Planning & Zoning Board

ZON23-00743

Central Mesa Reuse Pipeline

April 10, 2024

Alternative Landscape Plan

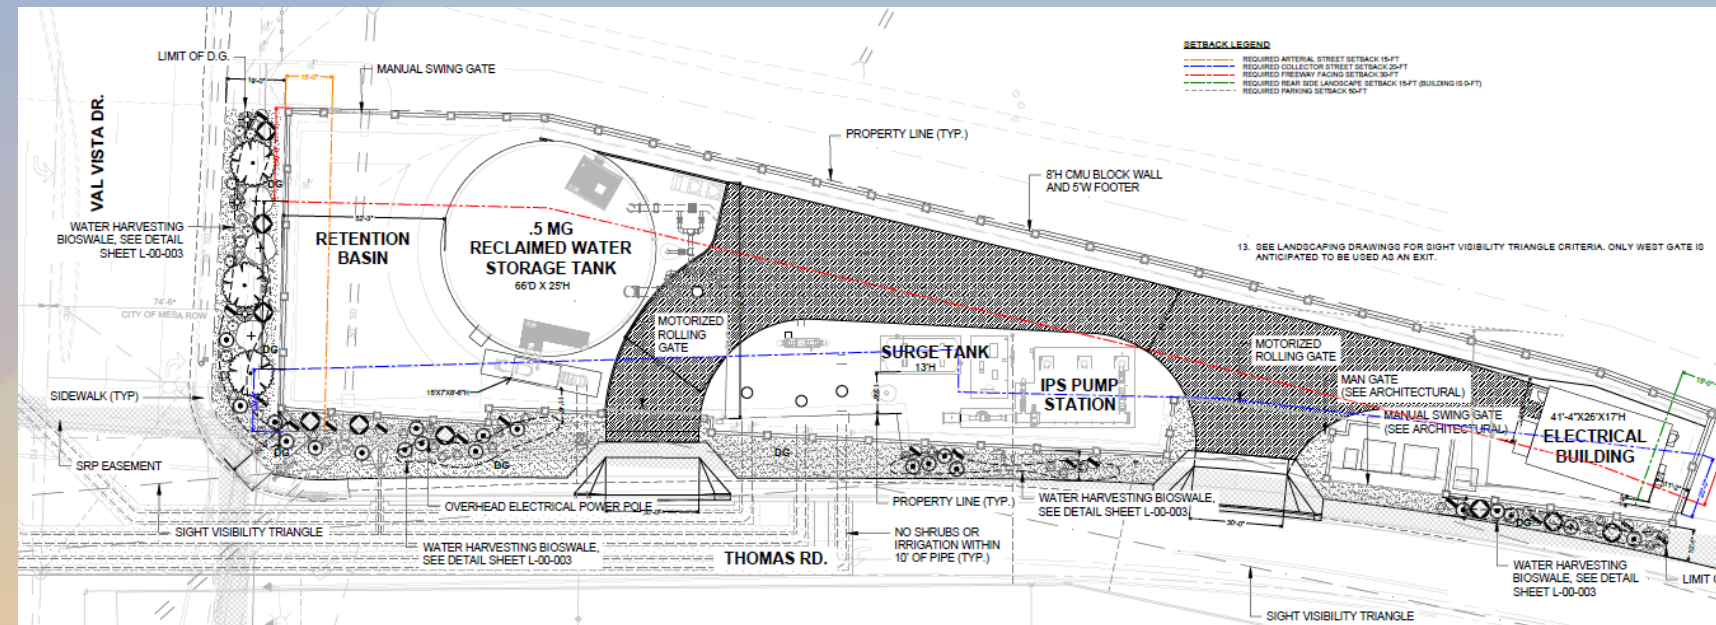
Concerns with lack of landscaping and trees on the site

- *Renderings were updated to better reflect the provided trees and shrubs on the site*

Design Review Board Comments

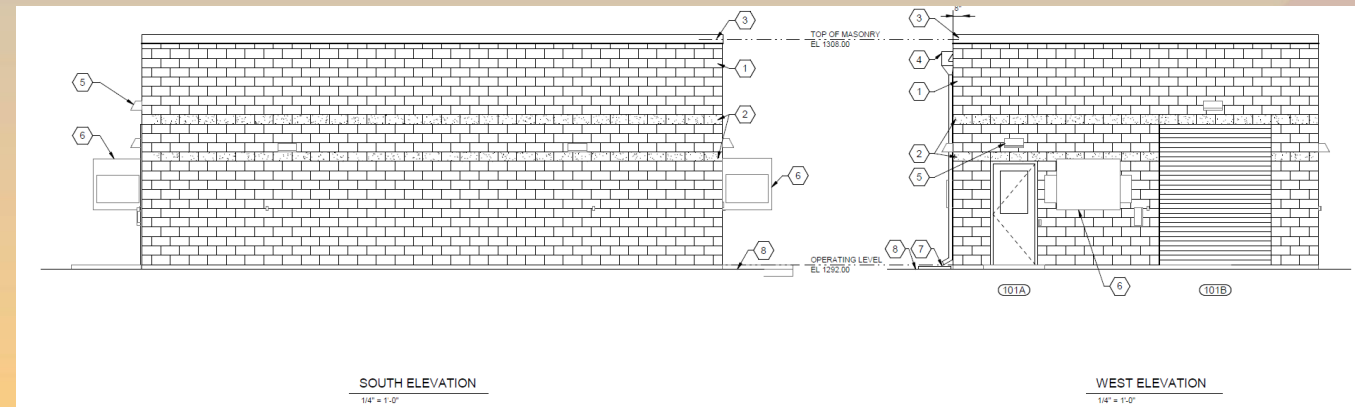
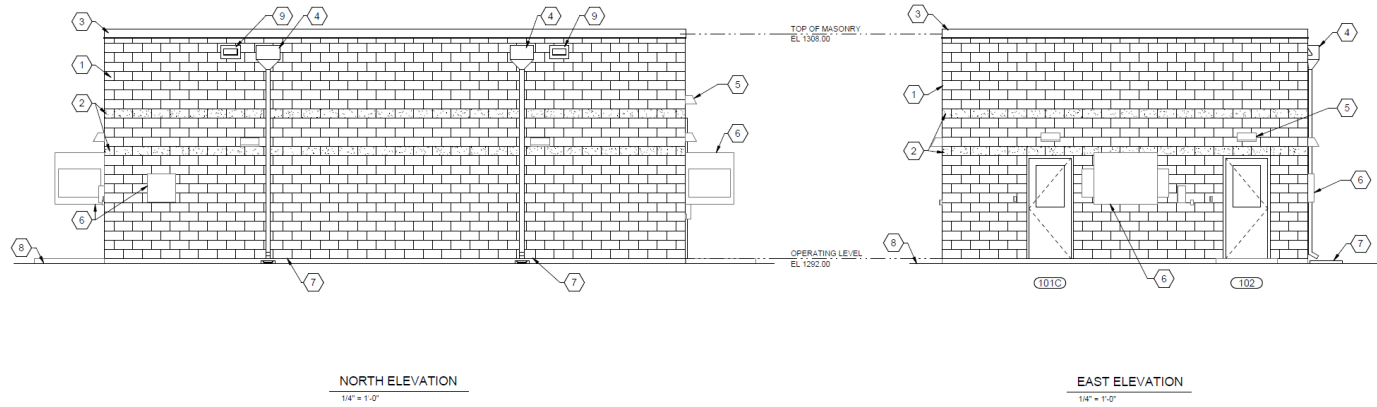
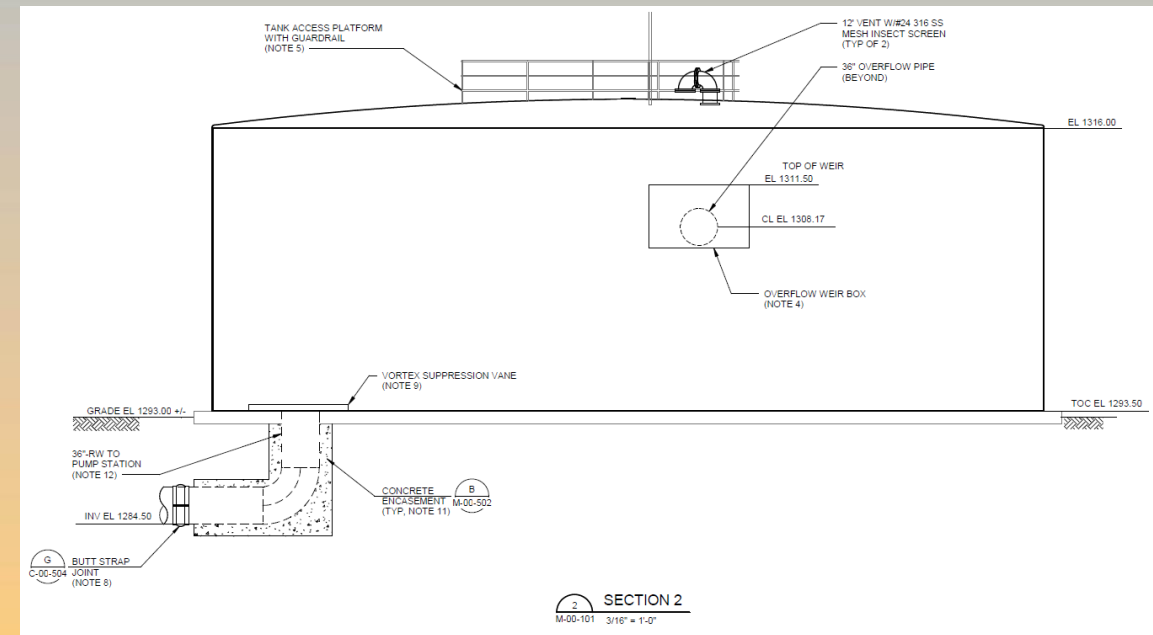
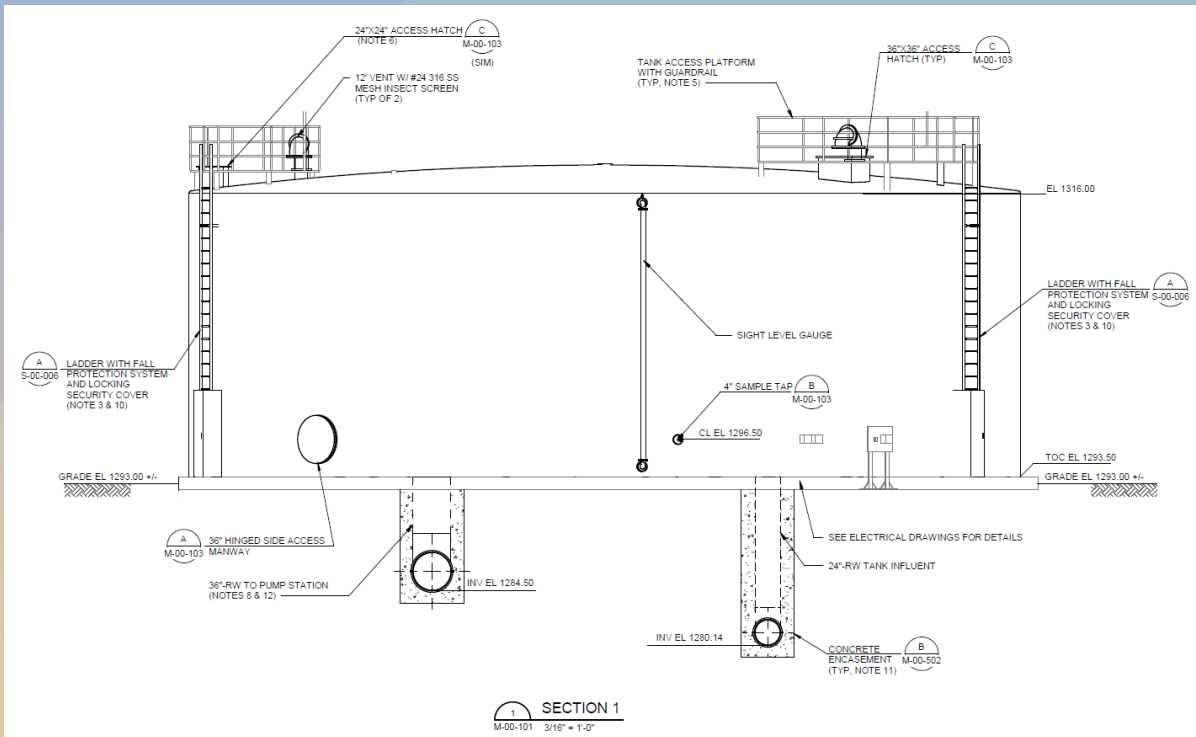
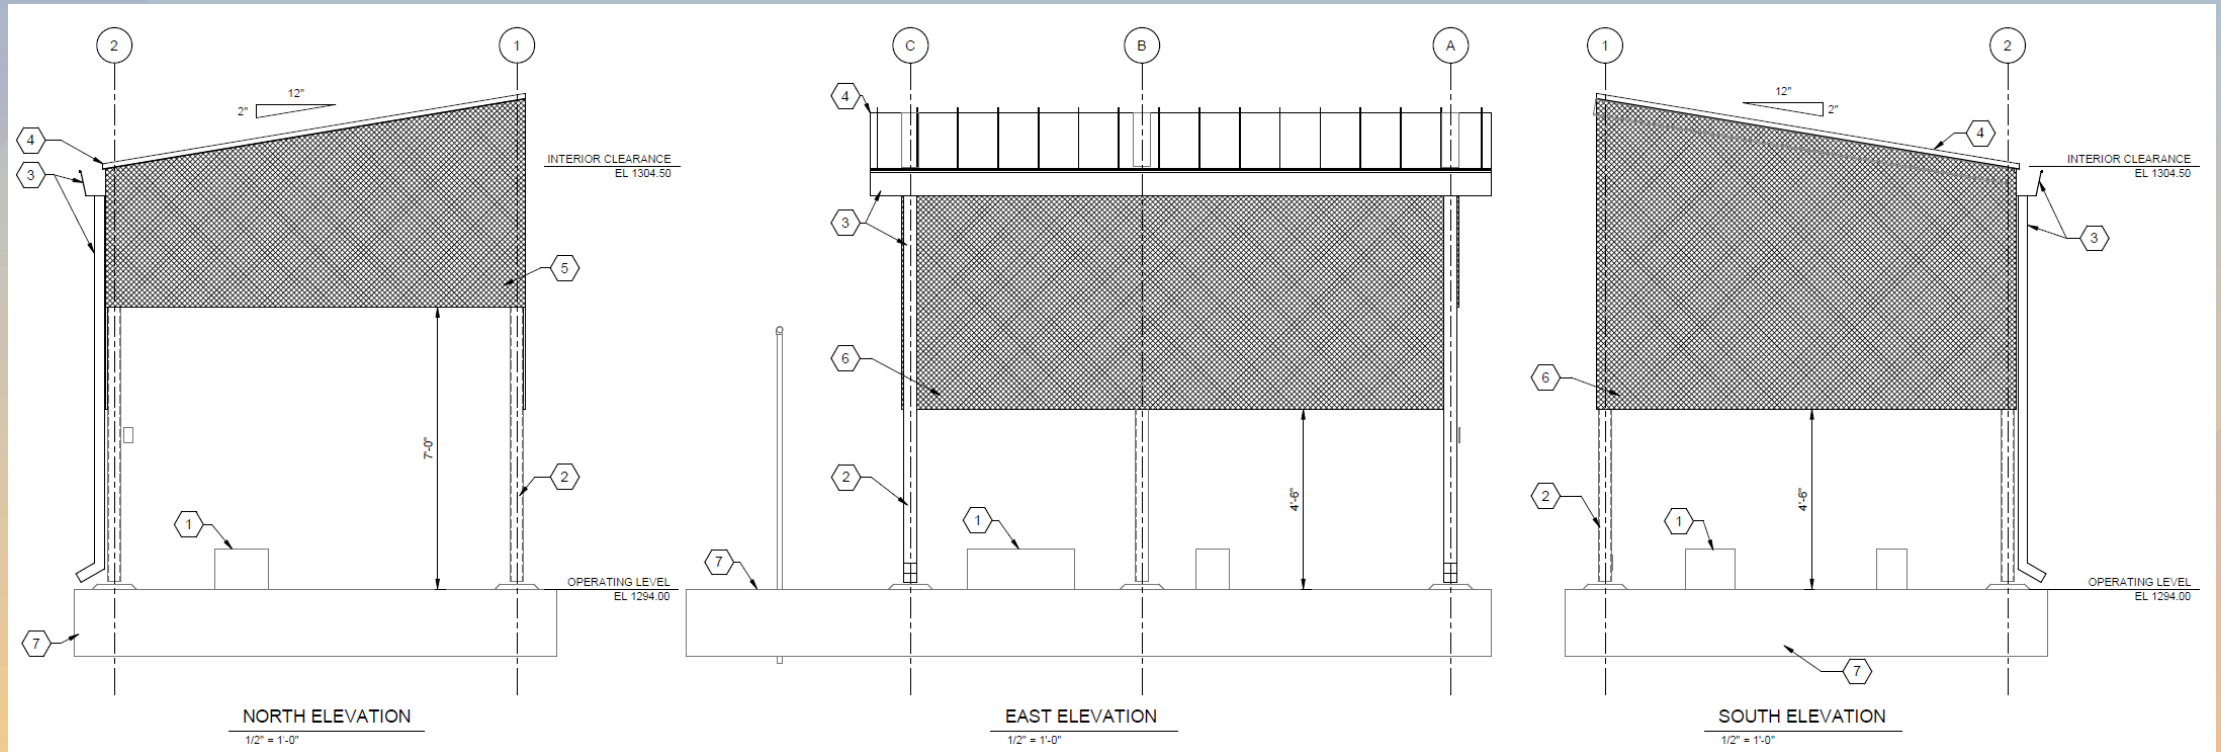
Concerns with the lack of screening

Requests a different color for the wall and the water tank

Requests lowering of the water tank height to the wall height

Requests a mural or mesa logo on the water tank

- *Renderings were updated with a more accurate perspective to better display the screening being provided for the site*

- *The color of both the wall and the water tank were updated to a more cohesive design while still referencing the design of the wall to surrounding communities*

- *Reduction of tank height is not able to be completed due to project requirements*

- *Artwork will be added to the site. The City will work with an artist to finalize the design and a condition of approval has been added to the case to reflect this*

PRIMARY SITE WALL ELEVATION

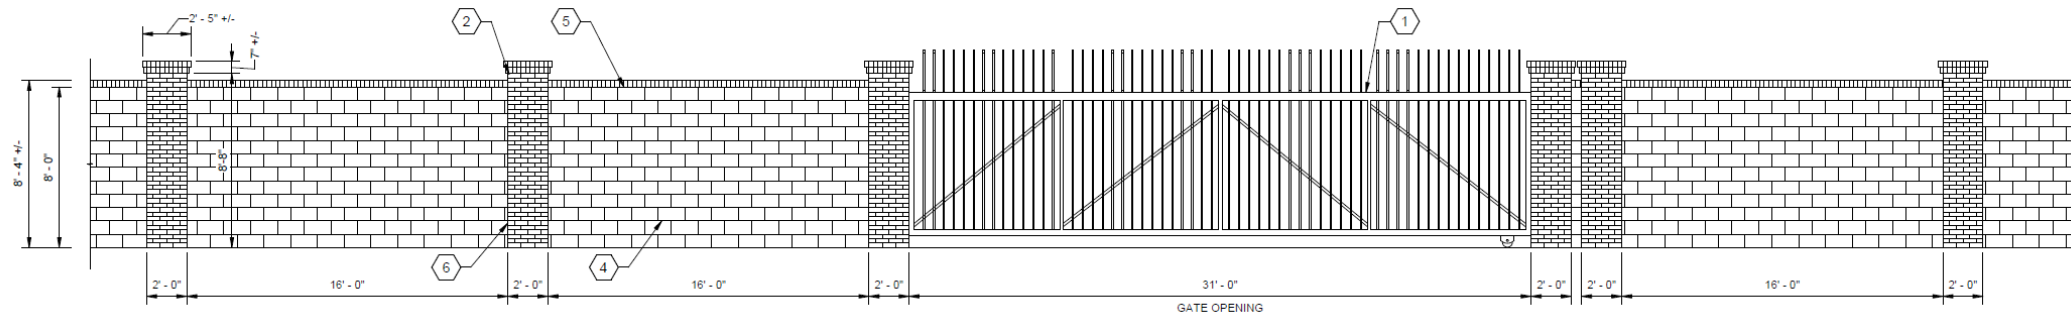
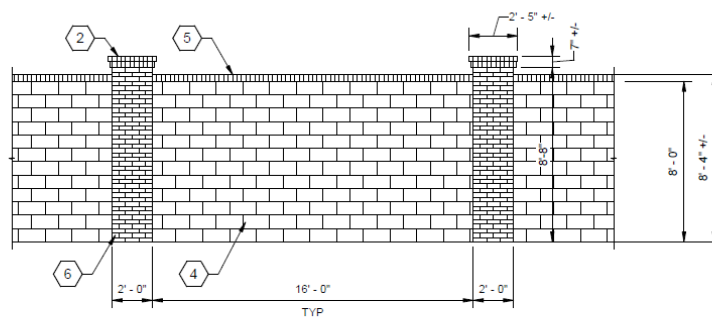
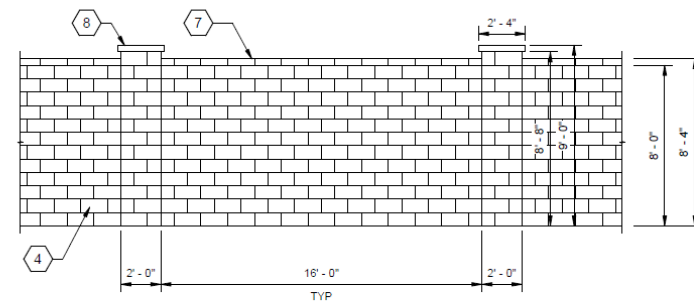
Wall design needs to be improved, recommend to move away from matching neighborhood wall and move to a green color

- *The wall and building were returned to the original darker block (willow green) and brick (graphite) color while maintaining the design to be cohesive with the surrounding communities*
